HAZWRAP Evaluation of Operable Unit 4 Interim Measure/Interim Remedial Action Environmental Assessment Decision Document

**Evaluation of the Rocky Flats Plant OU4 Solar Evaporation Pond
Interim Measures/Interim Remedial Action Environmental Assessment Decision Document**

HAZWRAP/ASG

Figure 1

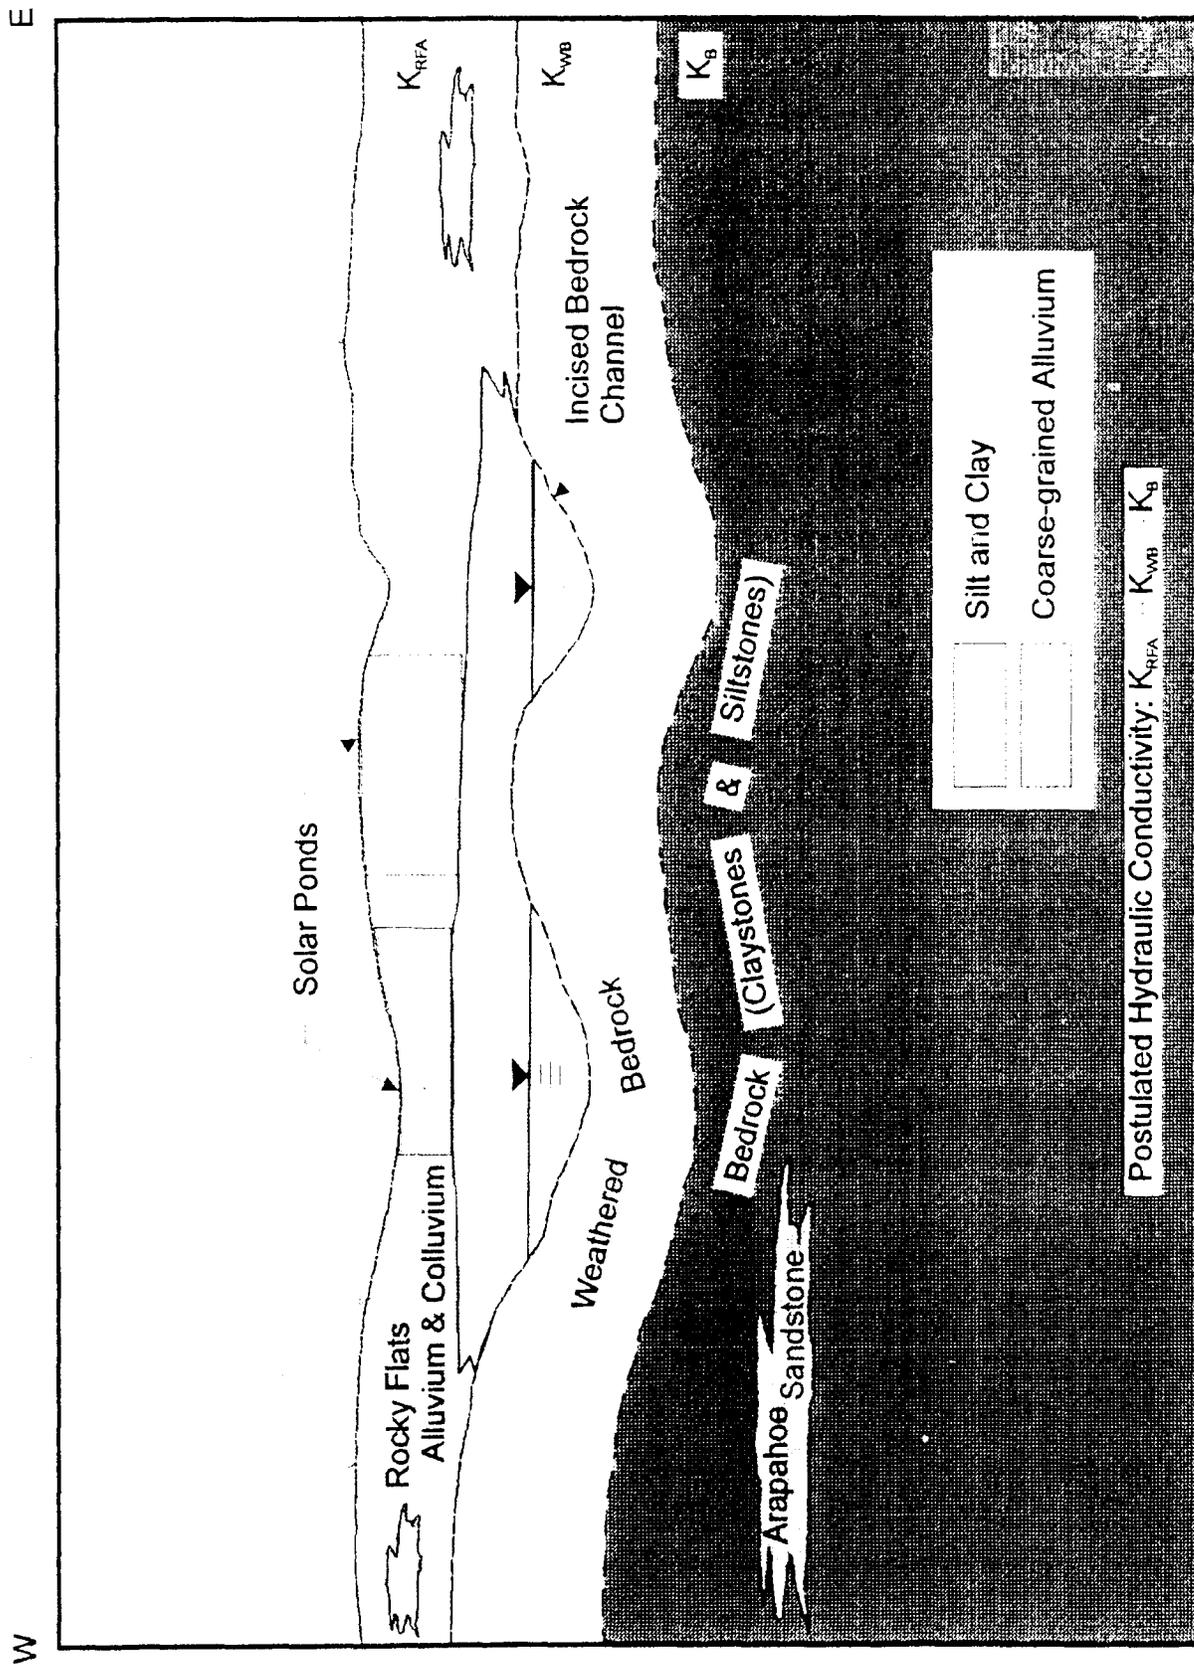
Alluvial materials in the bedrock channels are stated to be important preferred groundwater flow pathways throughout the volumes of the decision document, with the exception of Part V, the post-closure monitoring plan, where they are not explicitly considered when siting wells. Fig. 1 shows a conceptual model of flow in the hypothesized bedrock channels as described in the decision document. Fig. 2 shows the inferred locations of the bedrock channels as shown in the decision document.

Figure 3

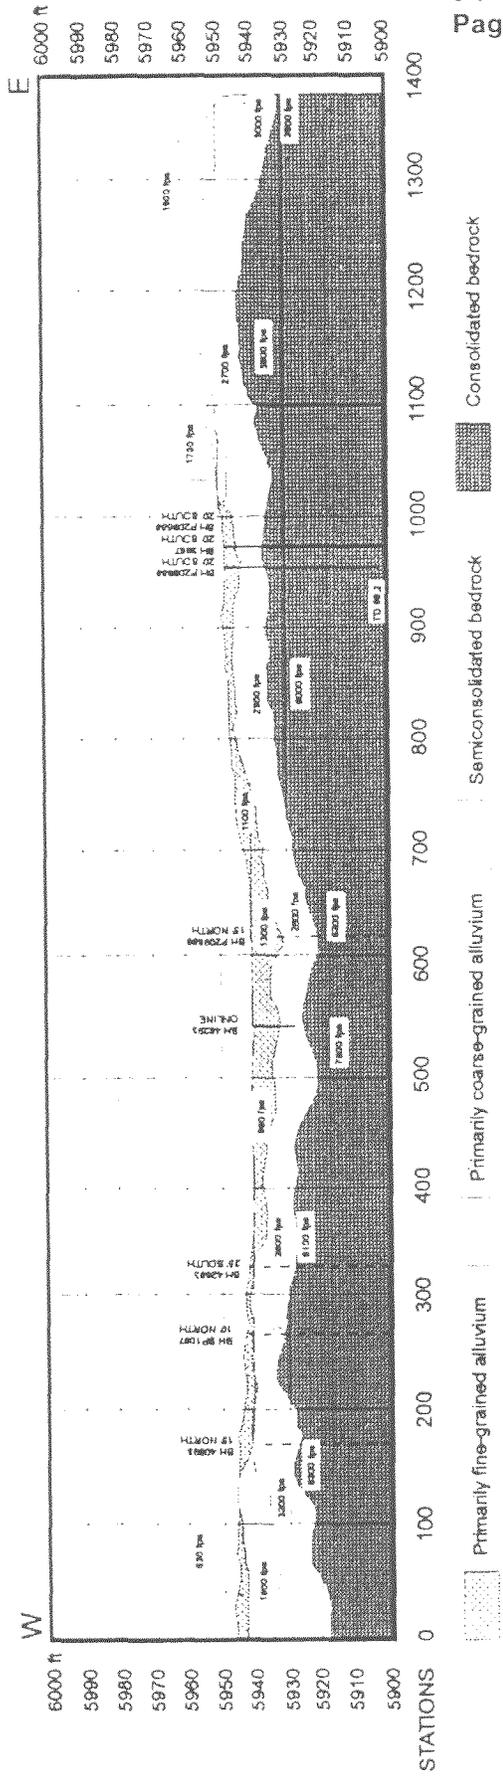
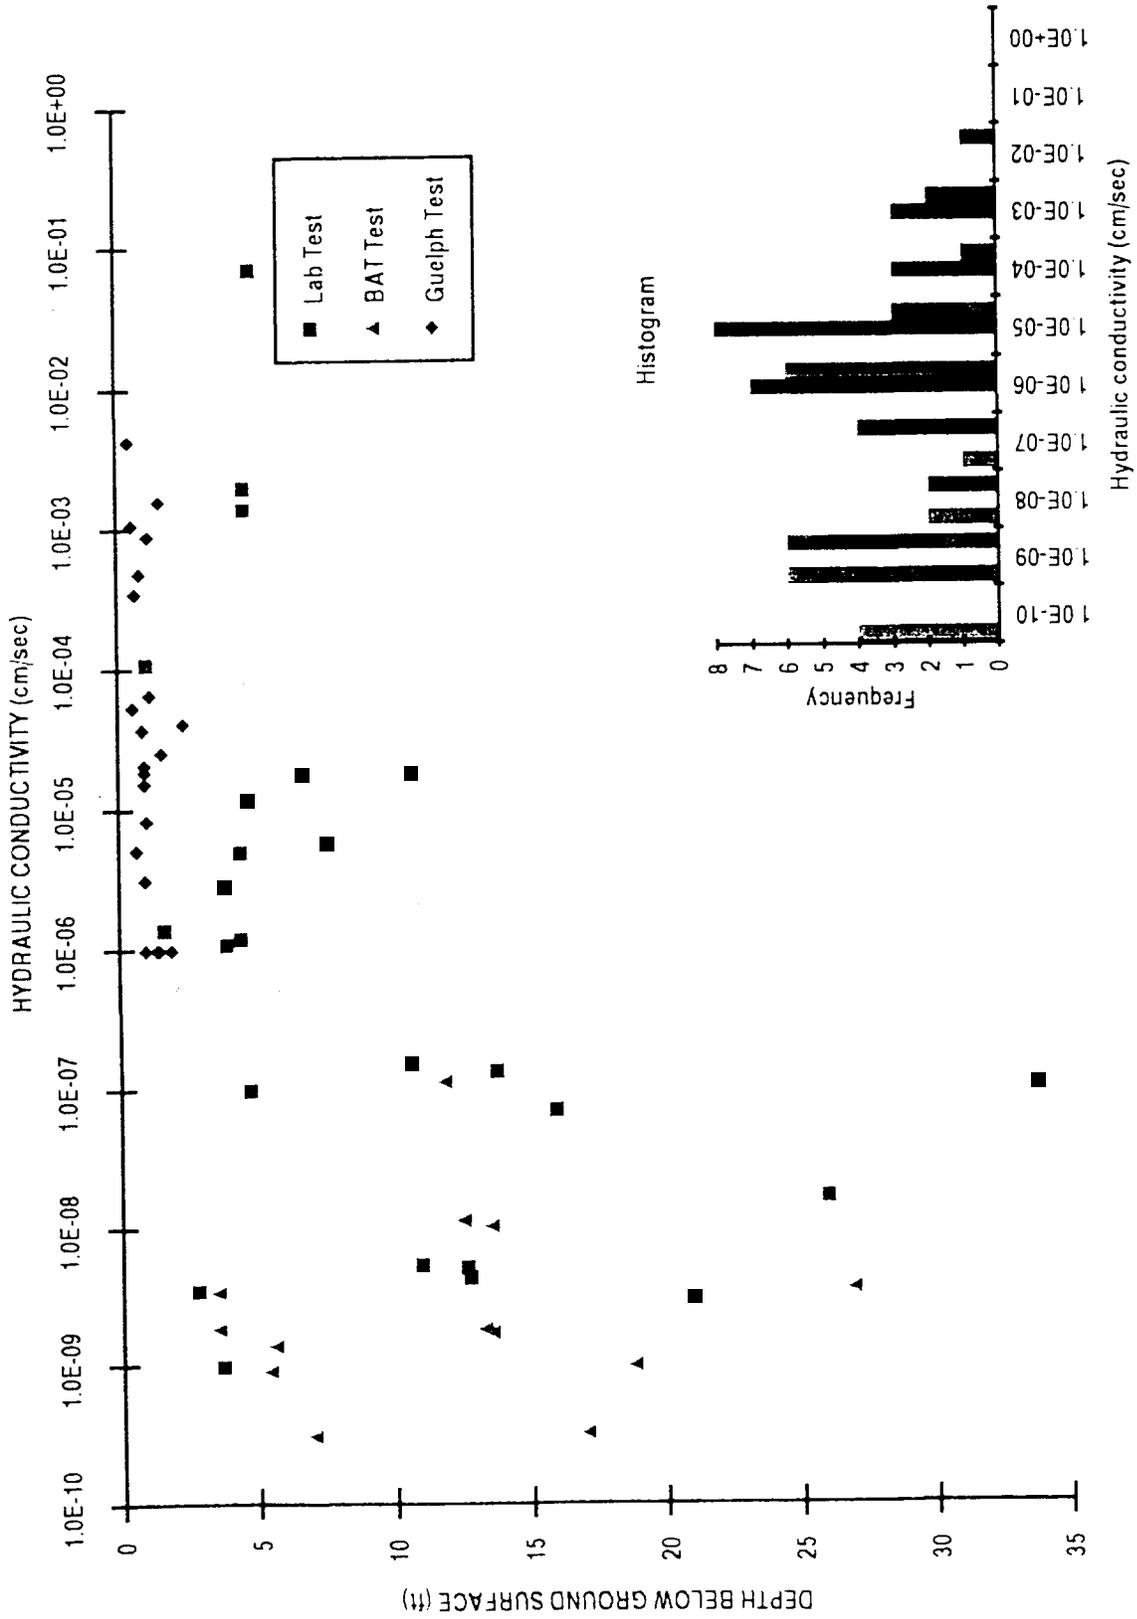
The first lines of evidence presented in the decision document for preferred flow in the bedrock channels are topographic and stratigraphic. The topography of the top of the bedrock (defined by the alluvium/colluvium-bedrock contact) is interpreted to contain the incised channels. The topography of the bedrock surface is inferred from boring logs and seismic refraction data. However, the existence of the channels is not supported by the borehole and seismic data. First, lithologic control in the critical area, the northern hillside, is very poor and cannot support the detailed top of bedrock contours drawn on decision document figures (e.g., Fig. II.3.5-14). Second, lithologic cross sections presented in the decision document either do not show any evidence of the incised channels at the mapped locations or do not show coarse-grained lithofacies in channels where there may be some evidence of their existence (Fig. 3).

GEOLOGICAL INTERPRETATIONS OF SEISMIC REFRACTION DATA LINE 5 (OU4 IM/IRA Decision Document)

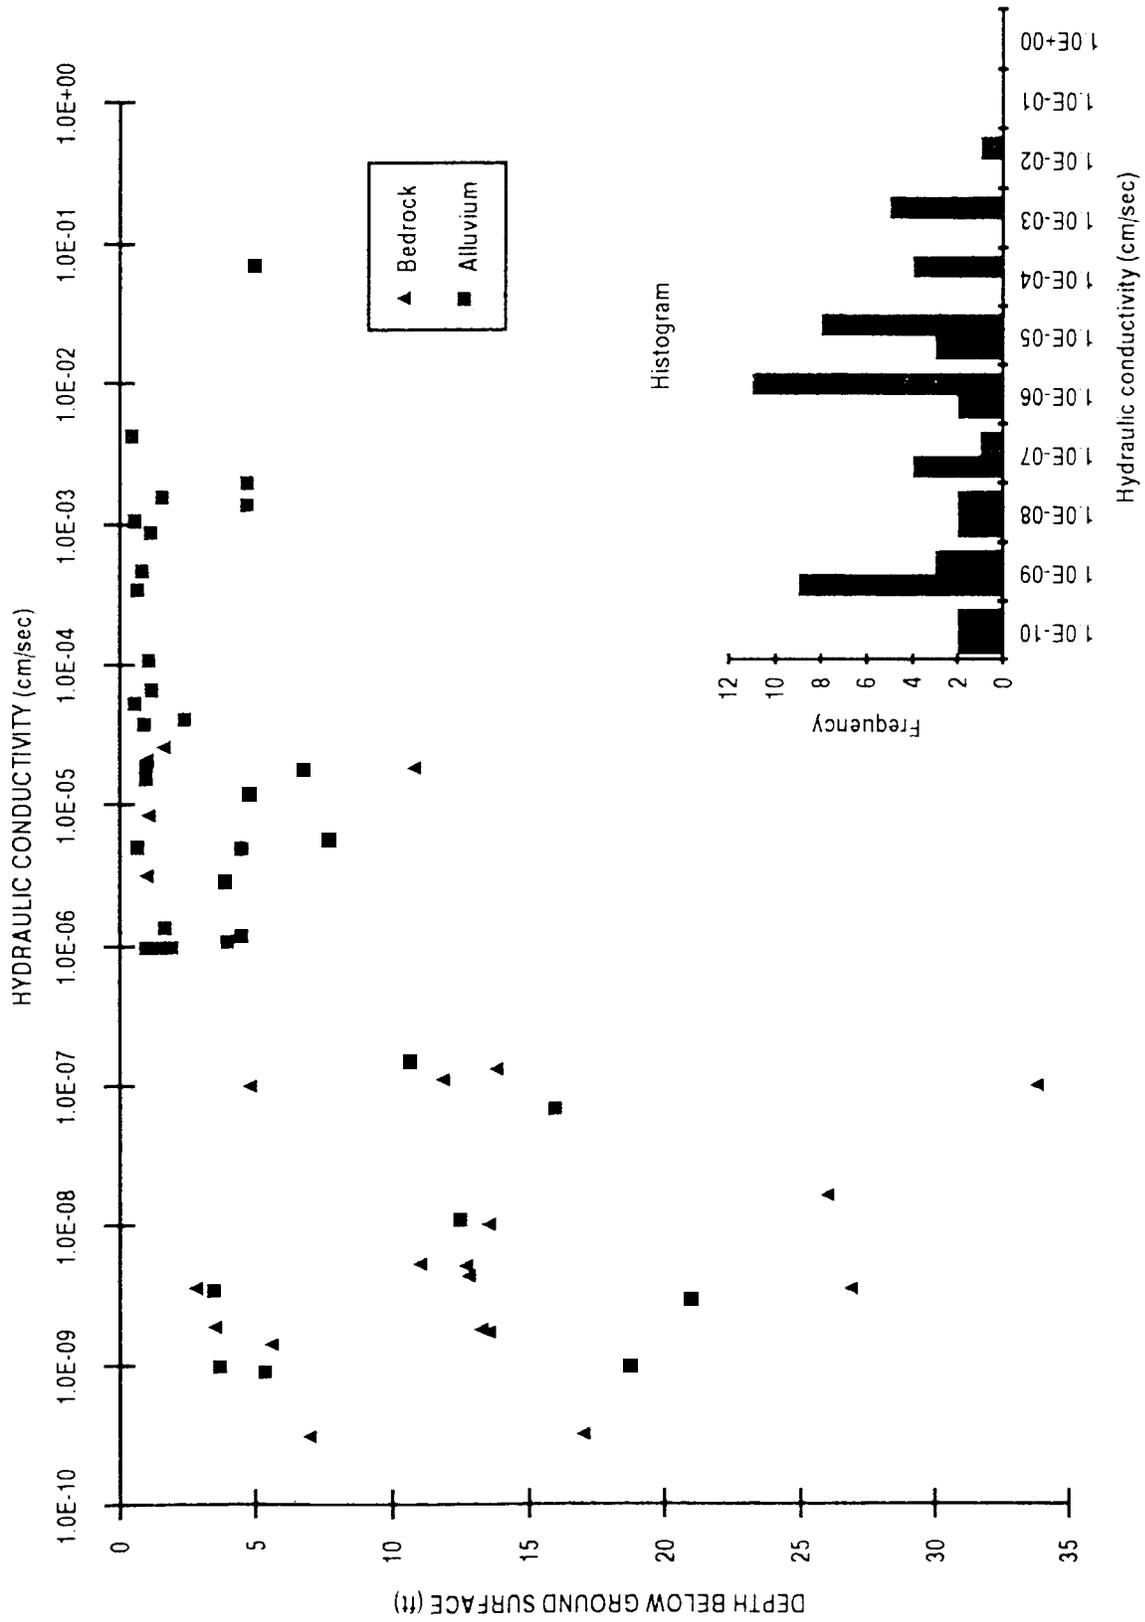
Second, even the interpretations presented do not appear to support the existence of the bedrock channels. For example seismic lines 2, 5, 6, and 7, which are perpendicular to the hypothesized channels, do not show significant relief or indicate large seismic velocity differences at the alluvium-bedrock contact (e.g., Fig. 3 and Fig. 7). They do indicate some relief and large velocity differences at the weathered bedrock-competent bedrock contact, indicating there may be some confusion about where the channels are supposed to be. In any case the evidence provided by the boring logs and seismic data need to be reanalyzed and interpretations carefully checked.

Figure 6

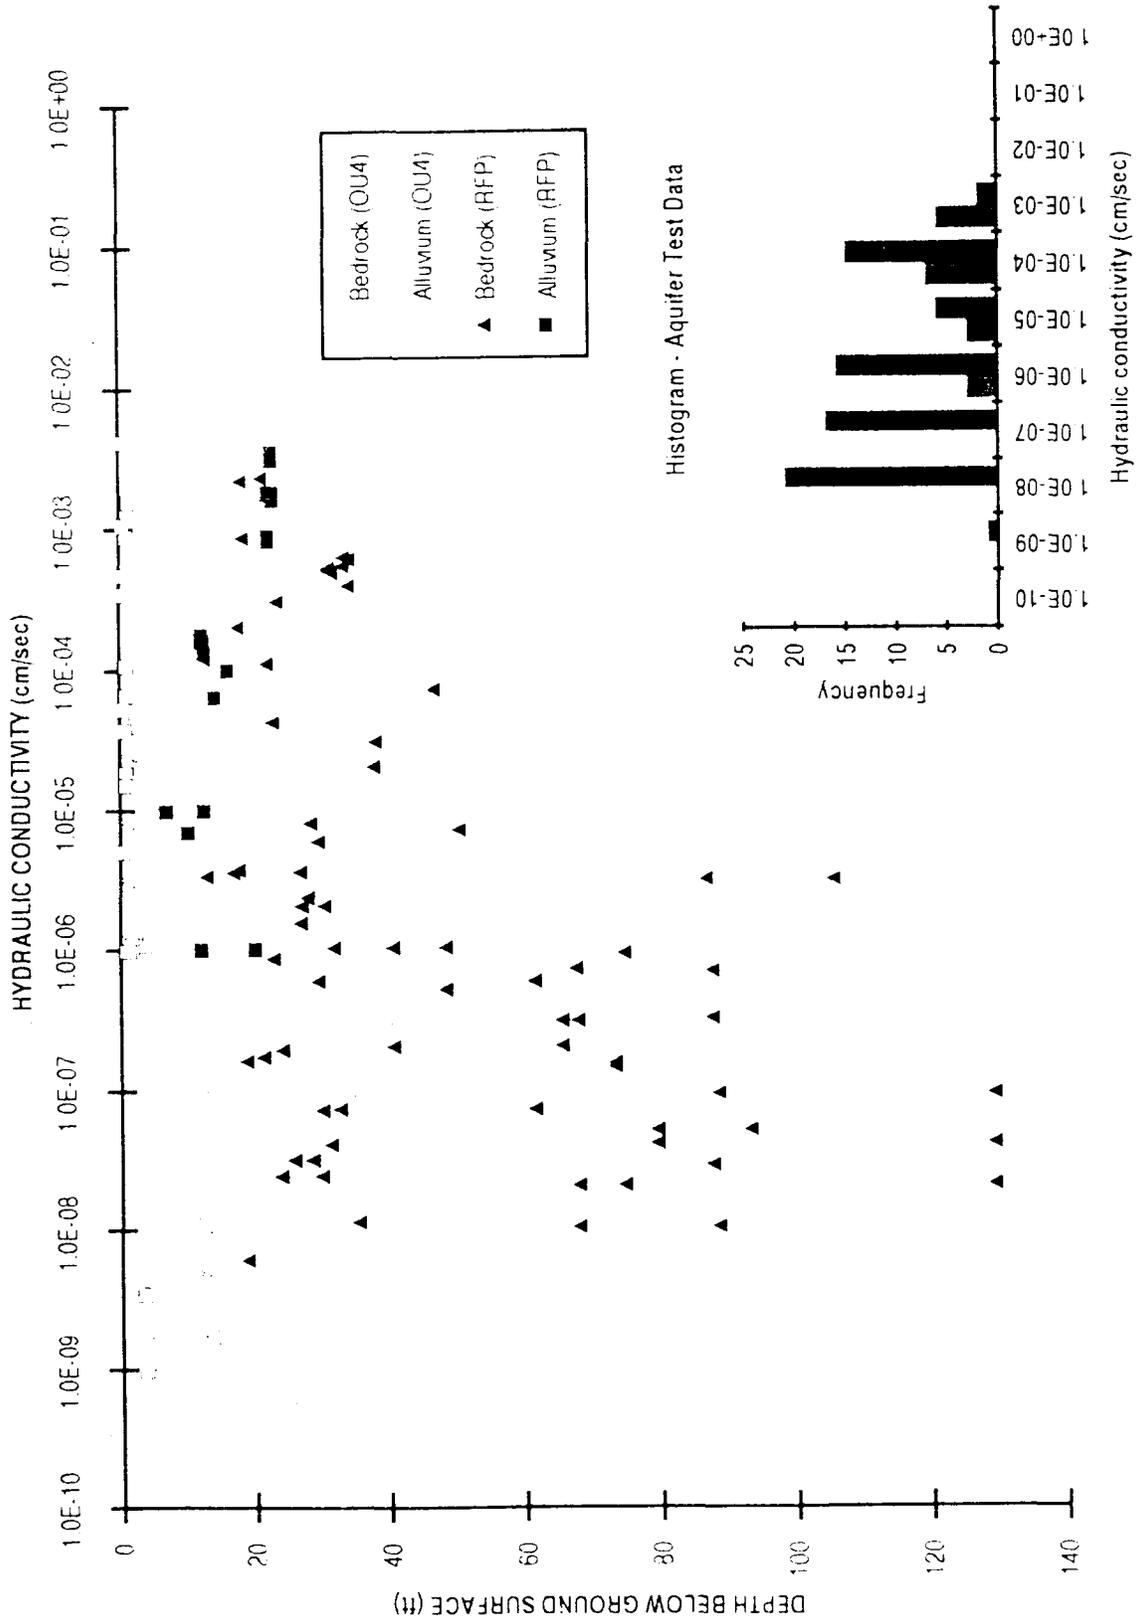
significantly higher saturated hydraulic conductivities (K) than underlying lithologies (i.e., $K_{\text{alluvium}} \gg K_{\text{weathered bedrock}}$). This contention is not well supported by the data. Results of K measurements are presented in the decision document for three different methodologies: insitu BATTM tests and Guelph permeameter tests, and laboratory determinations from "undisturbed samples". None of these methods can be expected to provide really accurate determinations of K; however, on a relative basis all methods indicate that Ks for alluvial and bedrock materials overlap (Fig. 4 and Fig. 5). The BATTM data plot separately on Fig. 4, and appear to be anomalously low, indicating that the data from that method may not be comparable to data from other methods. Aquifer test data from OU4 and other Rocky Flats OUs also indicate overlapping K values for alluvium and bedrock, especially for depths less than about 60 feet (Fig. 6).

Figure 7

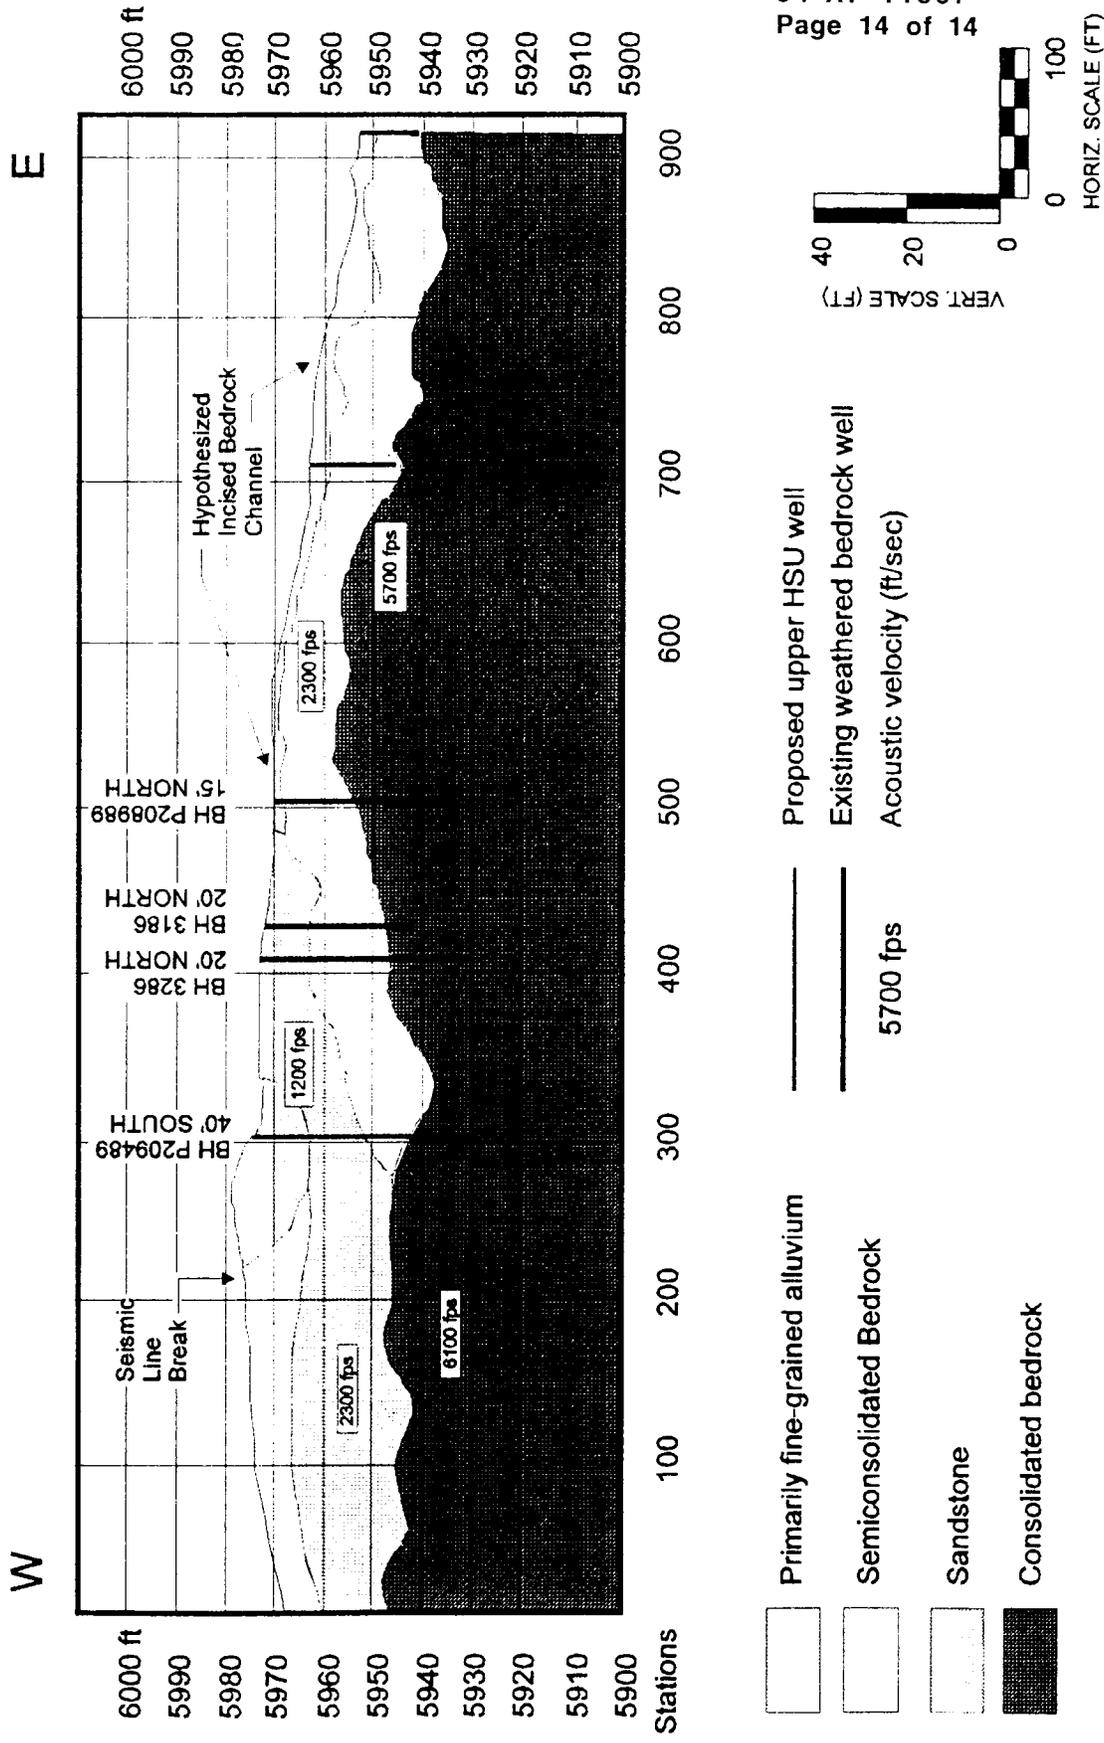
these were three separate hydrologic units. In addition, it does not discuss the possible existence of preferred migration pathways and specifically does not propose wells in mapped bedrock channels, the uppermost Arapahoe sandstone or in bedrock below the weathered zone (Fig. 7). Thus, the monitoring plan does not appear to have taken into account the conclusions of the Phase I Remedial Investigation Report. As discussed above, these particular conclusions are not necessarily correct; however, to be defensible the post-closure monitoring plan needs to be based on some clearly definable conceptual model that is supported by data.
